HISTORIC CONSERVATION BOARD AGENDA

Monday, April 10, 2017 at 3:00 pm

APPLICATION FOR AN AMENDMENT TO A PREVIOUSLY ISSUED CERTIFICATE OF APPROPRIATENESS HISTORIC CONSERVATION BOARD PUBLIC HEARING STAFF REPORT

APPLICATION #: COA2017016
APPLICANT: Hillman Point LLC
OWNER: Hillman Point LLC
ADDRESS: **208 and 210 Wade Street; 209, 211 and 213 Kemp Alley**
PARCELS: 081-0001-0071
ZONING: CC-A
OVERLAYS: Over-the-Rhine Historic Conservation
COMMUNITY: Over-the-Rhine
REPORT DATE: updated April 2, 2017
HEARING DATE: March 13, 2017, April 10, 2017
STAFF REVIEW: Beth Johnson, Urban Conservator

1 WADE STREET - PROPOSED ELEVATION REVISIONS
1/8" = 1'-0"

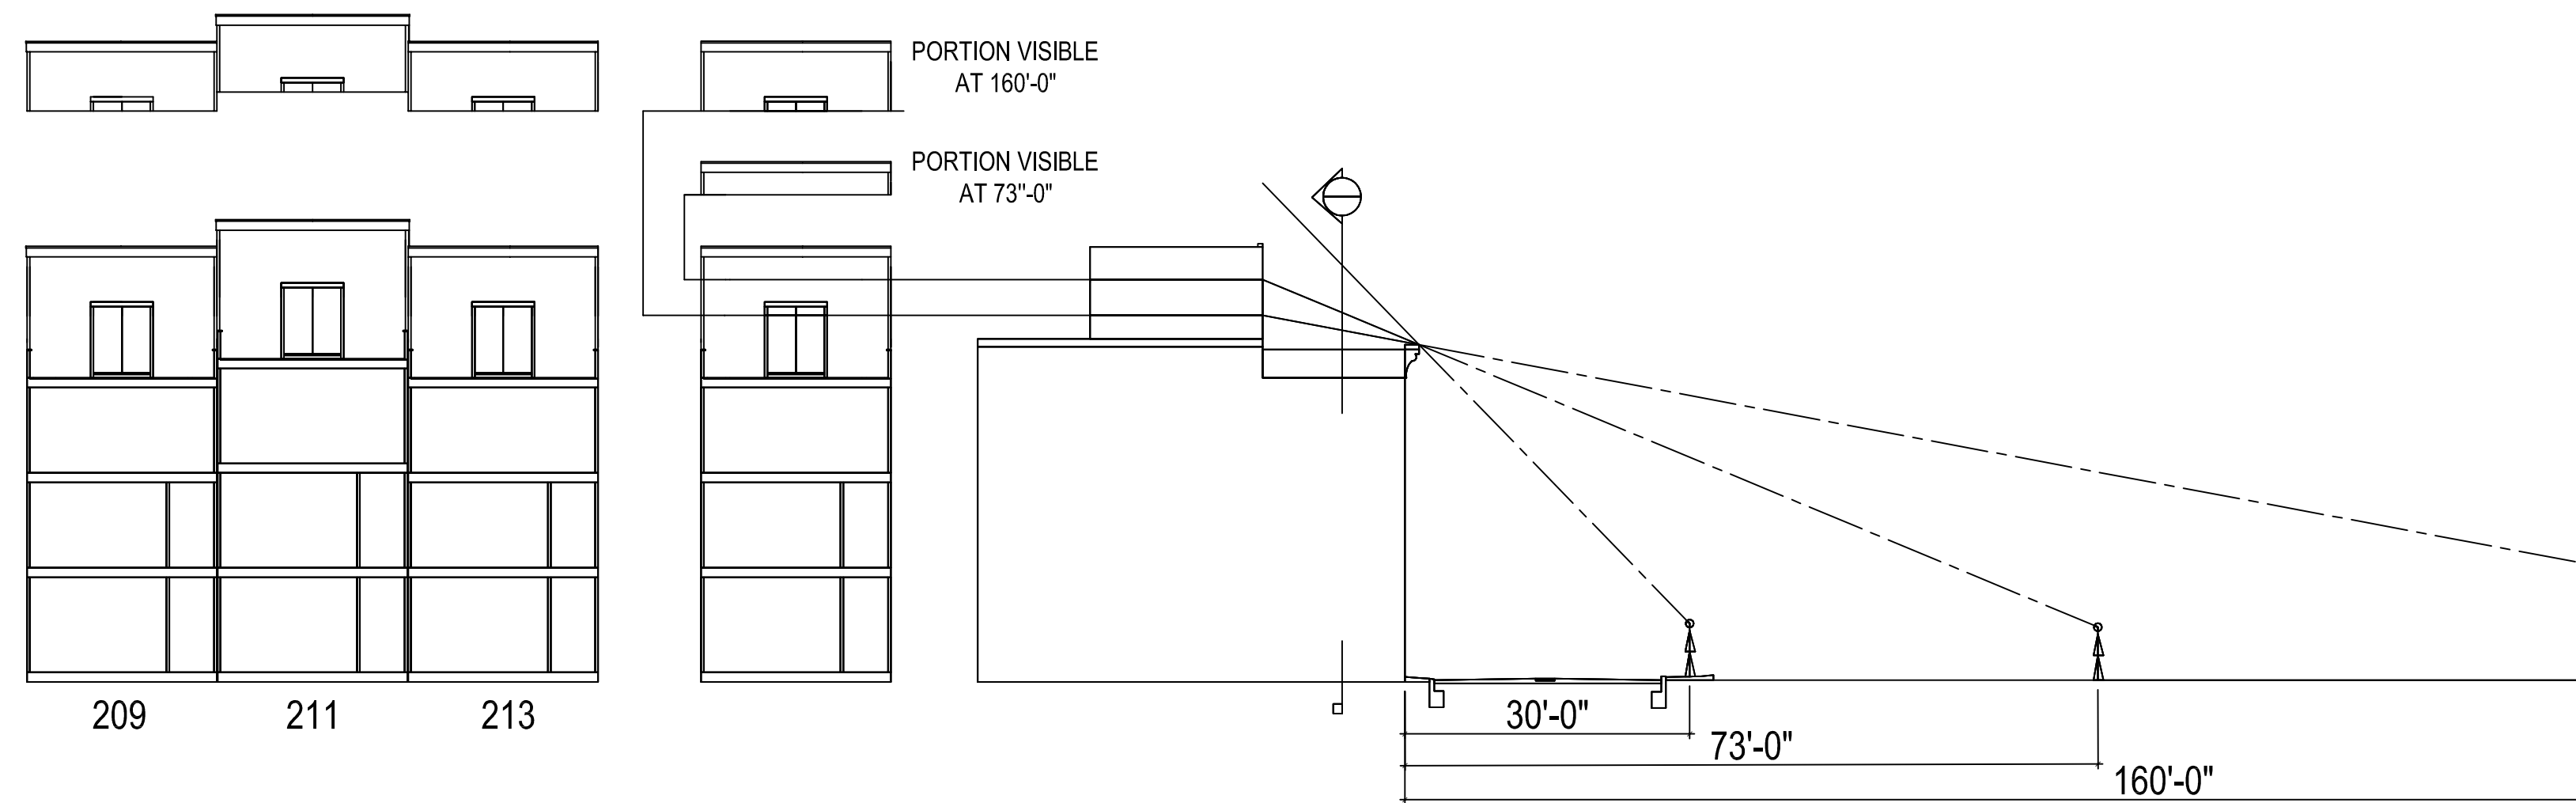
Design Changes: The applicants have adjusted the proposed design to have the façade walls at the fourth story extend the entire width of the building and have proposed them for both the Wade Street and Kemp Alley facades.

The applicants are proposing to keep the currently built gable roofs and along the Kemp Alley and Wade Street side built parapet walls that extend the entire width of the building. These walls will have a flat cornice line and there will be a simple horizontal band at the cornice line with no brackets.

1. The color of the parapet wall should be a gray or a muted neutral color.

Figure 3: Site Plan showing 503 Boal Street. The deck is a similar size to the deck on 501 Boal Street and the neighboring property at 505 Boal Street has a deeper lot and a bigger building.

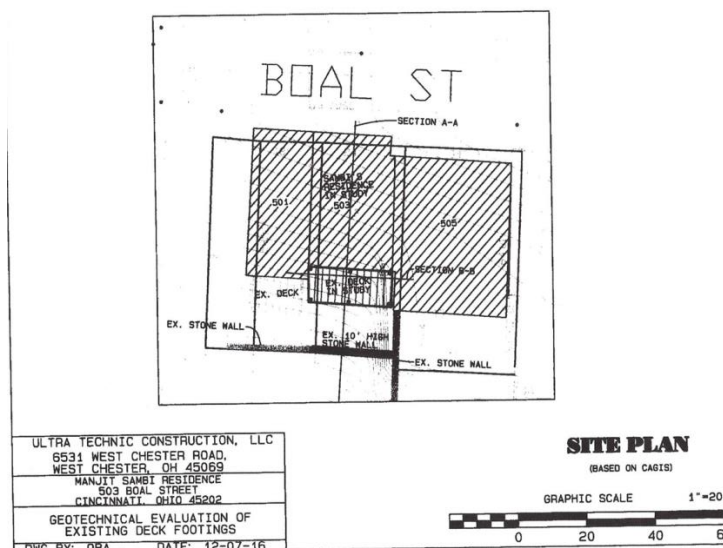
Staff is supportive of the request for a dimensional variance as the proposed lot is a smaller, substandard lot in the district and the proposed deck is in line with other approved requests within the district. The deck is below the roof line and will not cause harm to view sheds of neighboring properties.

1. **Section 1433-17– Dimensional Variance – APPROVE Dimensional Variance** of 8.25 feet to allow for a 10 yard rear setback at 503 Boal Street per plans submitted by the applicant, Manjit Sambhi, with their submission dated February 14, 2017.
2. **FINDING:** The Board makes this determination that per Section 1435-05-4:
 - a. Such relief from literal implication of the Zoning Code will not be materially detrimental to the public health, safety and welfare or injurious to property within the district or vicinity where property is located; and
 - b. Is necessary and appropriate in the interest of historic conservation so as not to adversely affect the historic architectural or aesthetic integrity of the district.

Figure 6: View the site from inside Washington Park. The arrow shows the visibility of the space where the top of the building would be. Image from Google Street Views

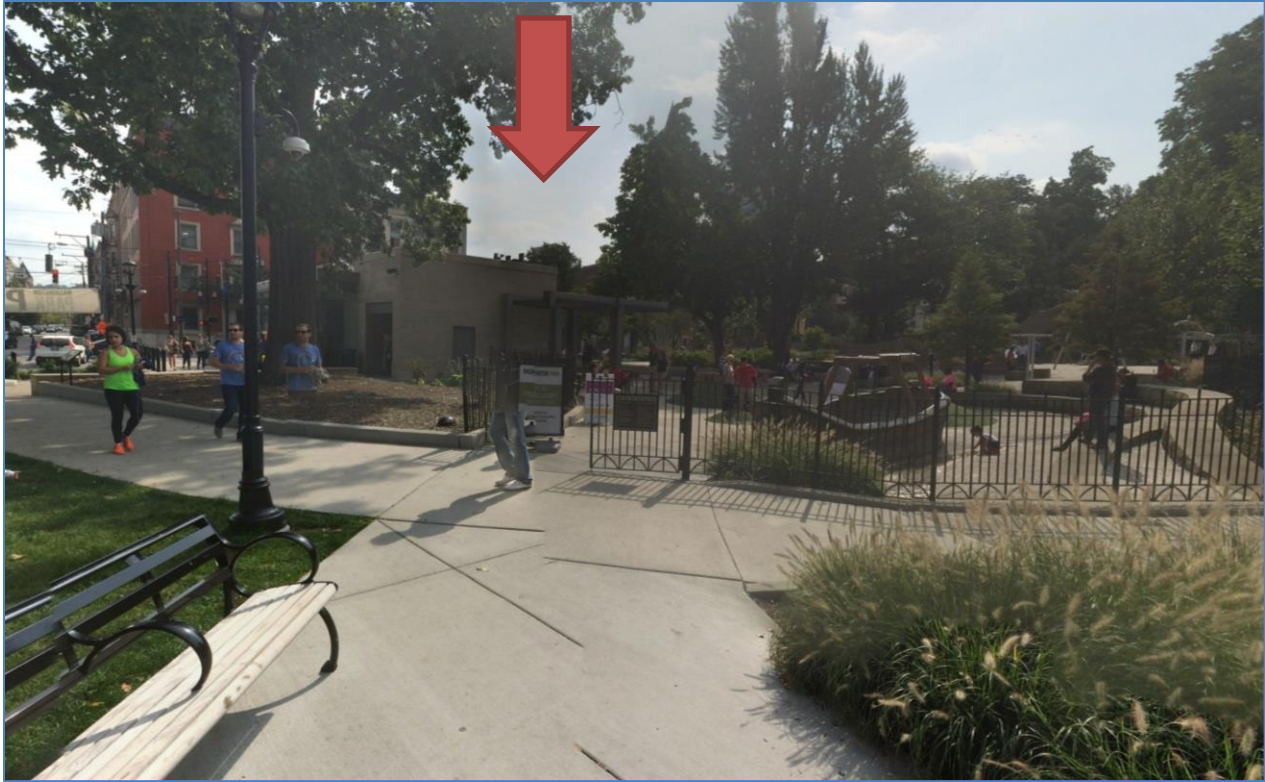
The Height of the portion of the building that is along the alley does not substantially conform to this guideline.
